**City of West Linn
PRE-APPLICATION CONFERENCE MEETING
REVISED SUMMARY NOTES
June 2, 2011**

SUBJECT: Chase Bank at 19080 Willamette Drive

Transparency

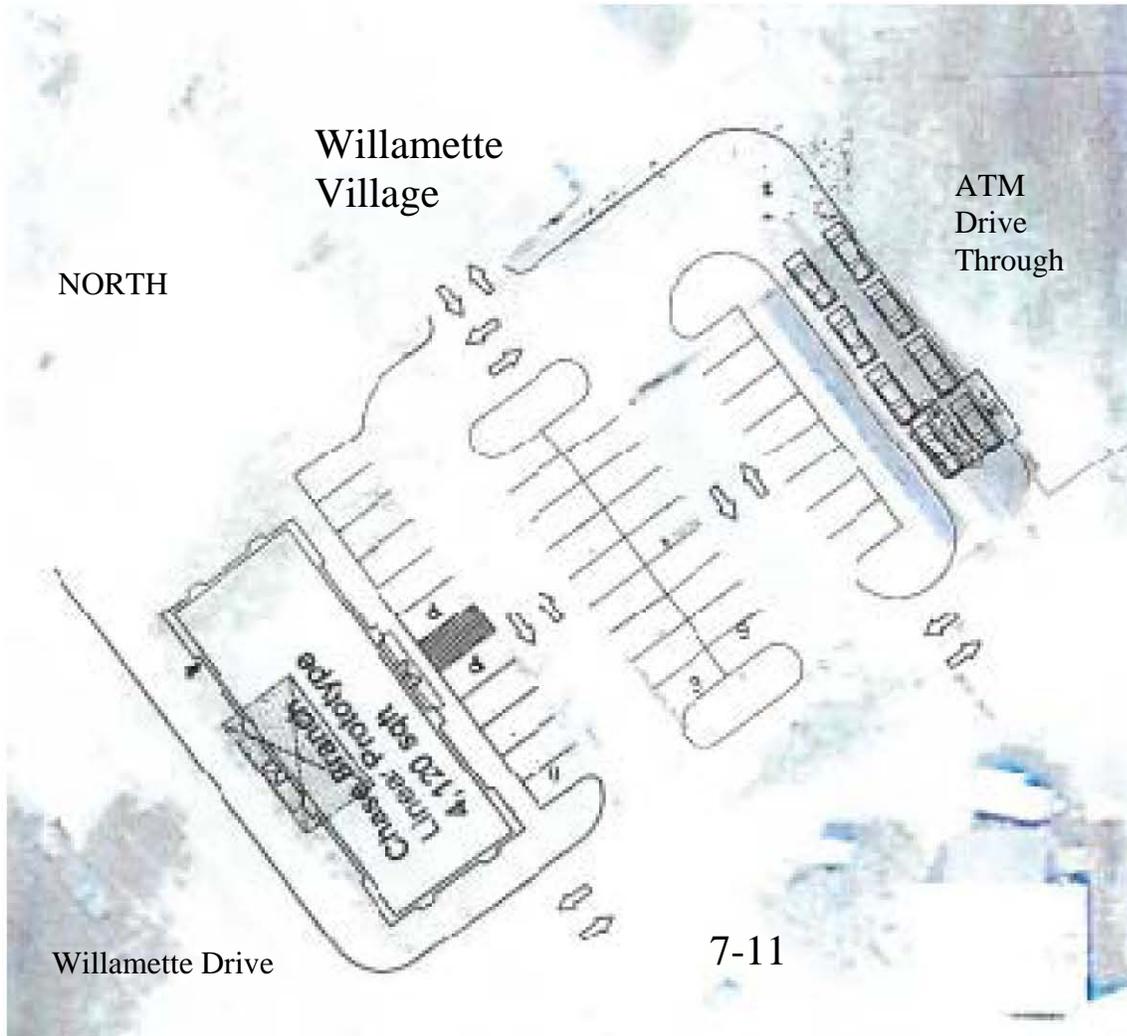
The transparency requirements of CDC 55.100(B)(6)(f) must be met. Sixty percent of the lineal frontage of the Willamette Drive elevation must have windows. At least one of the north or south facing elevations needs 30 percent transparency too. Glass must be clear and cannot be mirrored or smoked etc. The west facing or main elevation on Willamette Drive has about 53% transparency. That's good but it needs to be increased to meet the 60% standard. Both north and south facing elevation are blank. This is a problem.

The CDC allows for "transferring" window square footage. Thus it would be possible for the applicant to get credit for any surplus transparency on a re-designed front or side elevation. The applicant could apply for a variance: requesting that transparency on the rear elevation be "transferred" or credited to the front or side elevations. The applicant could strengthen the variance request by adding some acceptable kind of wall decoration, bas relief, art work etc. on those blank elevations. The applicant mentioned using a faux window with a poster inside. Staff is agreeable to looking at a drawing or photograph of how that would look but it sounds like that would still have to be attached to a variance request.
